DEVIZES; PROPOSED WAITING RESTRICTIONS**RECOMMENDATIONS FOR AMENDMENTS TO PROPOSALS**

<u>Road</u>	<u>Recommendation</u>
Avon Terrace	Implement as Advertised
Rotherstone	Implement as Advertised
Colston Road	Implement Proposal with Amendments <i>See details below</i>

Colston Road

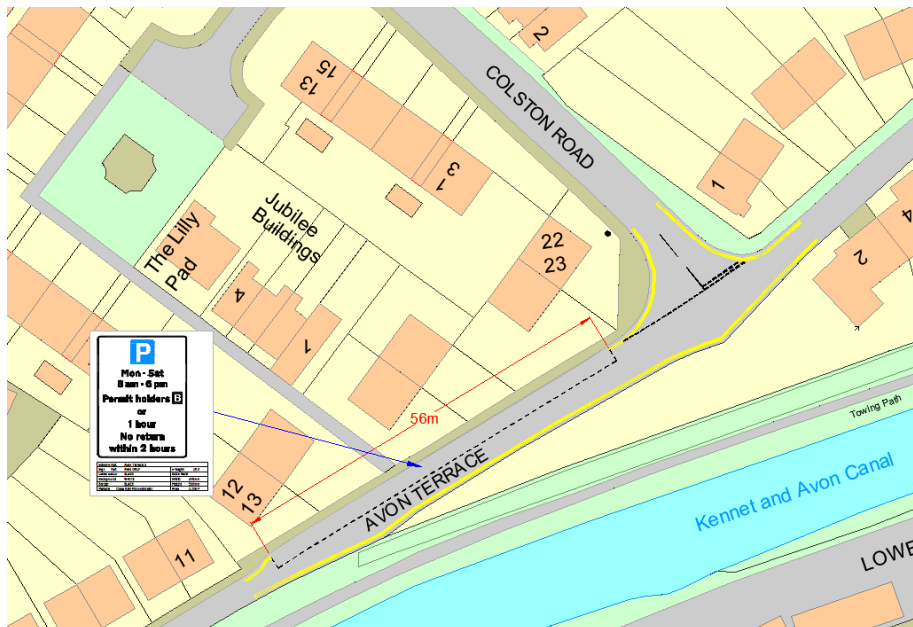
Further to the comments received during the consultation it is recommended to reduce the extent of the proposals. The proposal can be reduced to maximise the availability of on-street parking, whilst still preventing parking too close to the Avon Terrace/Rotherstone junction, to prevent parking on both sides of the road on the approach to the junction.
